STAFF REPORT
(Preliminary Plat)

CASE NUMBER: SUB 2000-84 -- DOWNS COUNTRY ESTATES

STAFF REPORT
(Final Plat, Preliminary Plat Approved 10/12/00)

VICINITY MAP

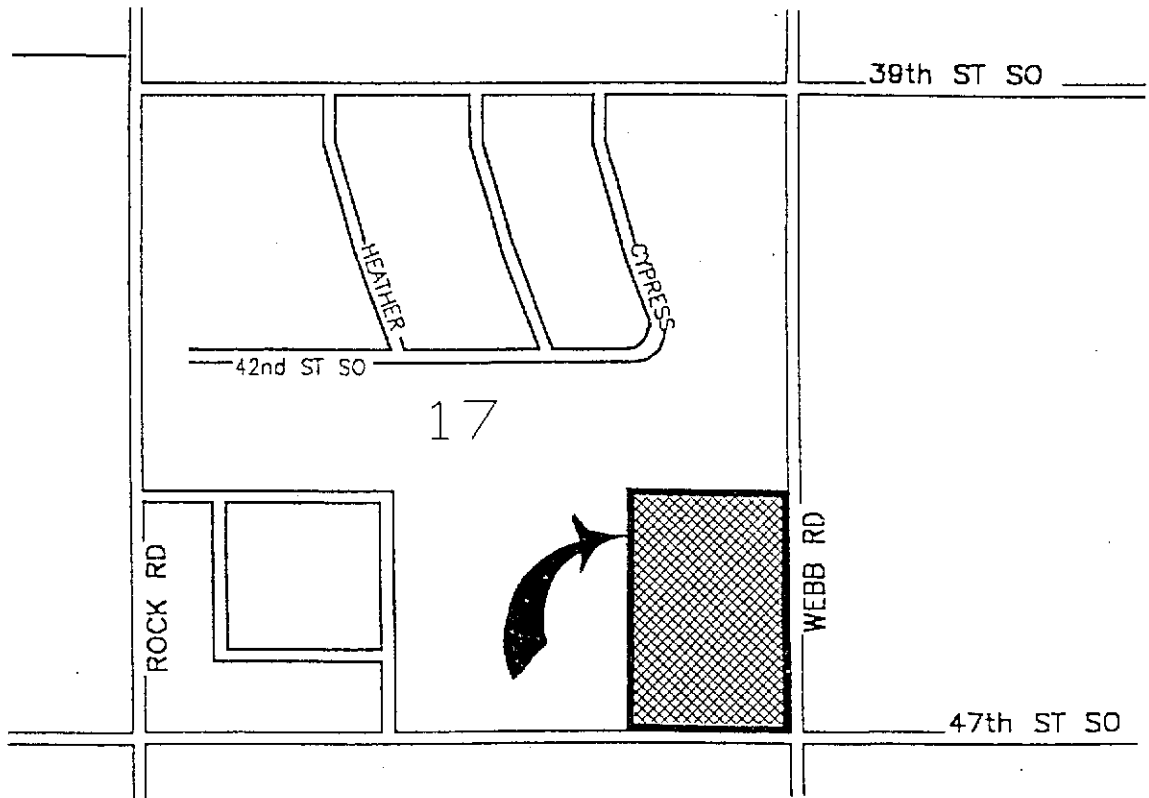
Note: This site is located in the County in an area designated as "rural" by the Wichita-Sedgwick County Comprehensive Plan. The Applicant proposes a private drive to access Lots 5, 6 and 7.

MAPD recommends the Subdivision Committee deny approval of this plat. Proposed access to six out of the ten lots is from the perimeter streets. Both MAPD and County Engineering recommend a reconfiguration of the plat denoting street access to internal lots. MAPD also recommends an east-west public street connection to the adjoining property to the west.

- C. County Engineering needs to comment on the status of the applicant's drainage plan. *A drainage plan is needed. A minimum pad should be established for some lots per the drainage plan. There appear to be terraces or drop structures on the site. The Applicant shall coordinate the removal or modification of terraces with NRCS (721-6127).*

- D. The plat proposes one access opening per lot along 47th St. South and Webb Road. County Engineering needs to comment on the access controls; and the need for a minimum distance between the private street and the access openings for Lots 4 and 8. The final plat shall reference the access controls in the plat's text.

VICINITY MAP

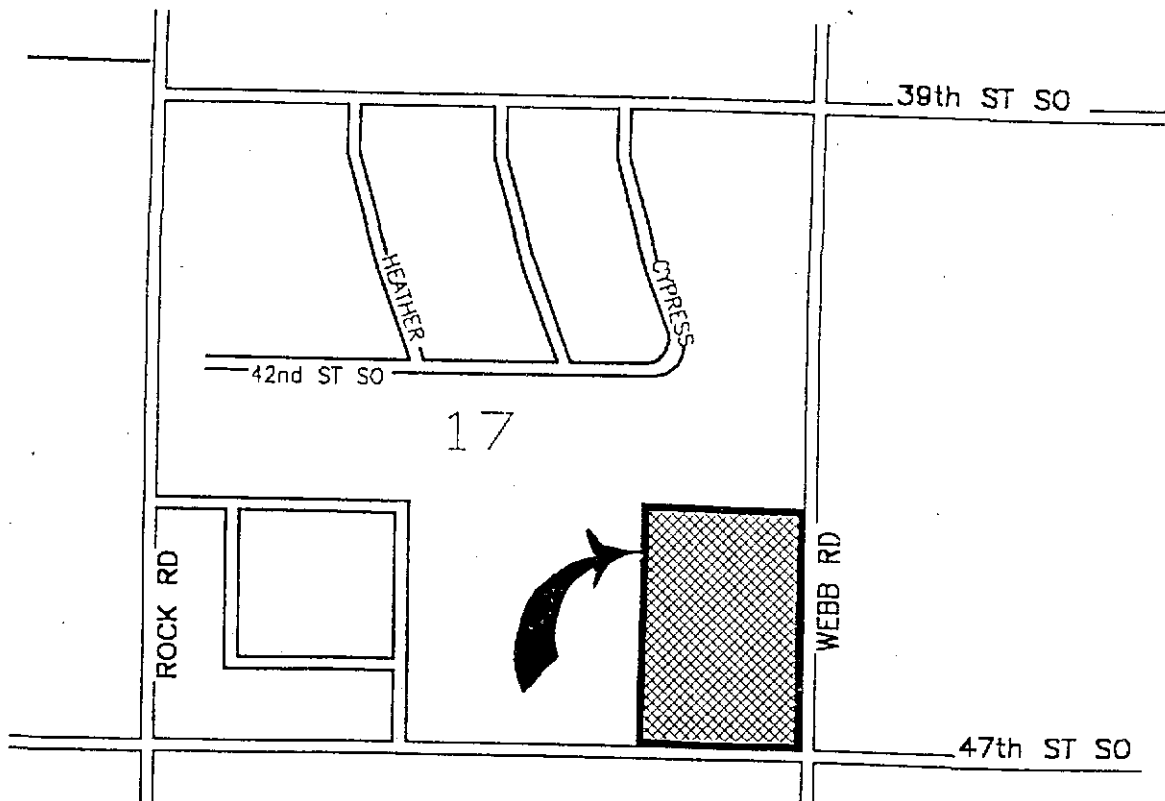
The plat has been revised to include a dedication of a 70-ft public right-of-way and contingent right-of-way dedication extending to the west as required by the Subdivision Committee.

- D. County Engineering needs to comment on the status of the applicant's drainage plan. The minimum pad elevation for Lot 9 should be revised to read "1346".

- E. The final plat shall reference the access controls in the plat's text. The Subdivision Committee approved a shared opening between Lots 1 and 2. Lots 4 and 8 shall have access from the internal street. Lot 10 shall have access through a private road extending through Lot 9 or Lot 7.
